Houston Lighting & Power

ST-HL-AE-2257

South Texas Project
Units 1 and 2
Docket Nos. STN 50-498, STN 50-499
Revised FSAR Radiation Zone Figures

Figure 12.3.1-1

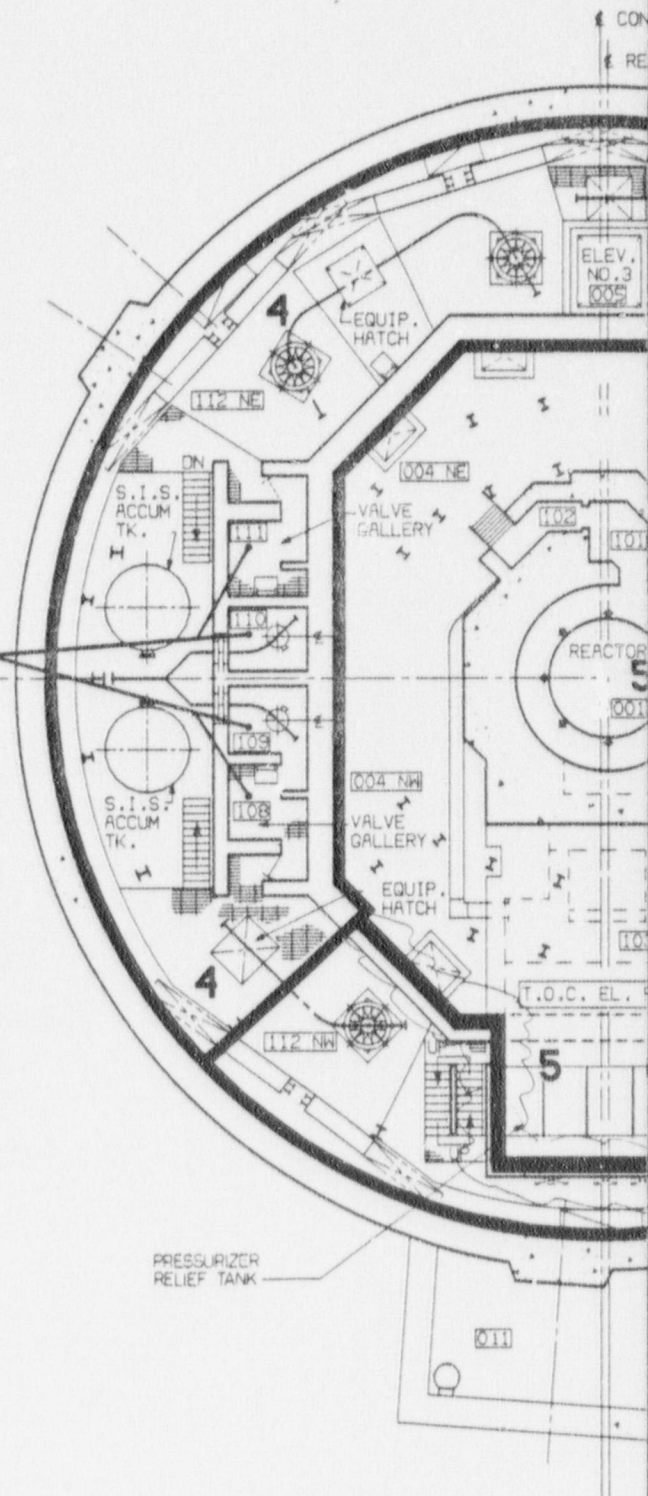
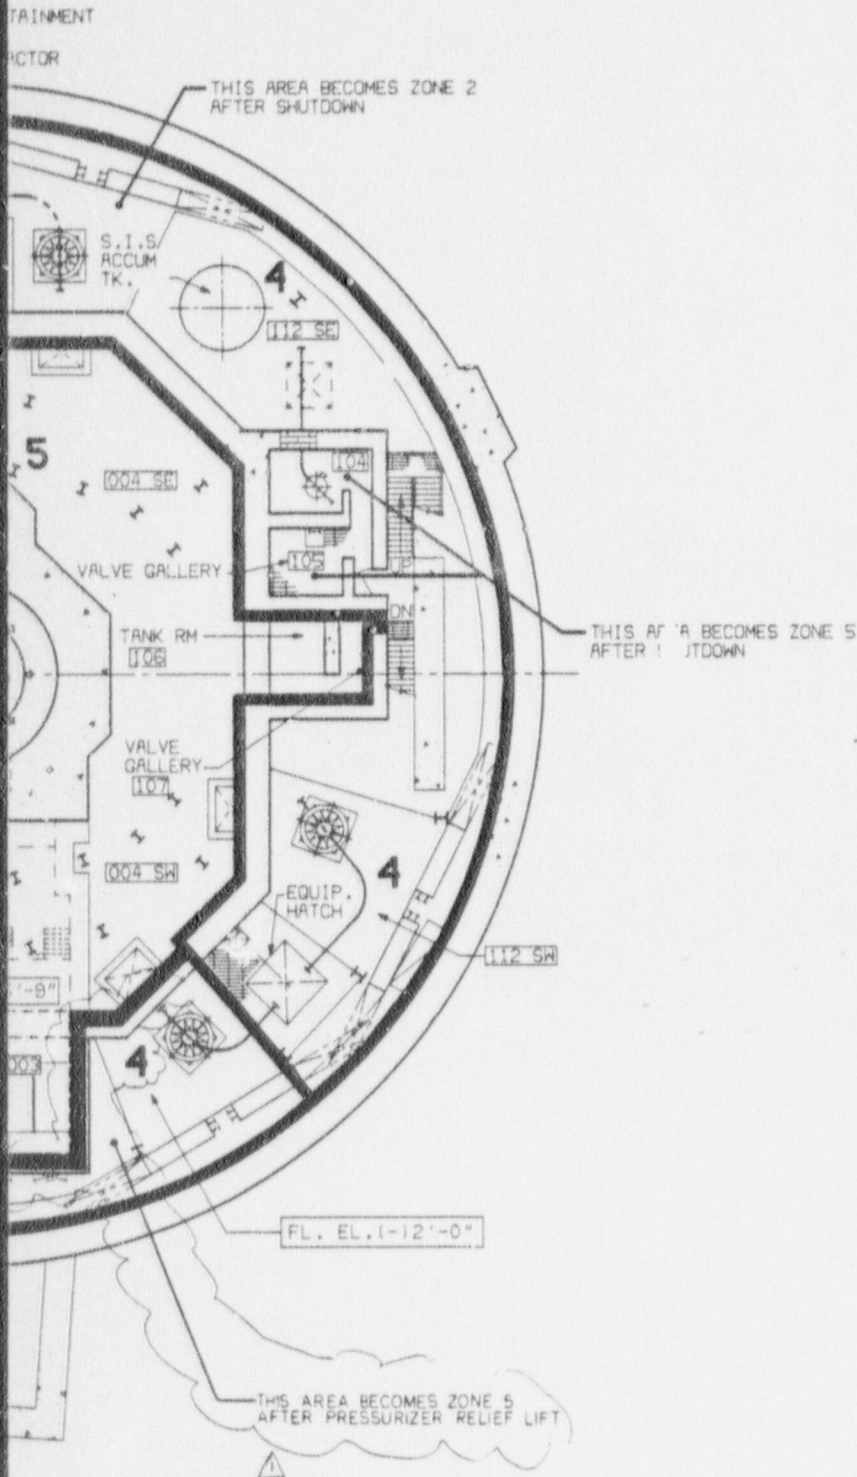
Attached are revised FSAR Figures 12.3.1-1 through 12.3.1-4 regarding the radiation zones (normal operation) for the reactor containment building (RCB), elevations (-)11'-3", (-)2'-0", 19'-0", and 37' 3". As a result of a reanalysis by Bechtel which includes the lifting of the pressurizer relief valve, area 308 SW could become a radiation zone 5 after the postulated lifting of a pressurizer relief valve. This is specifically noted on the attached figures.

THIS AREA BECOMES ZONE 5
AFTER SHUTDOWN
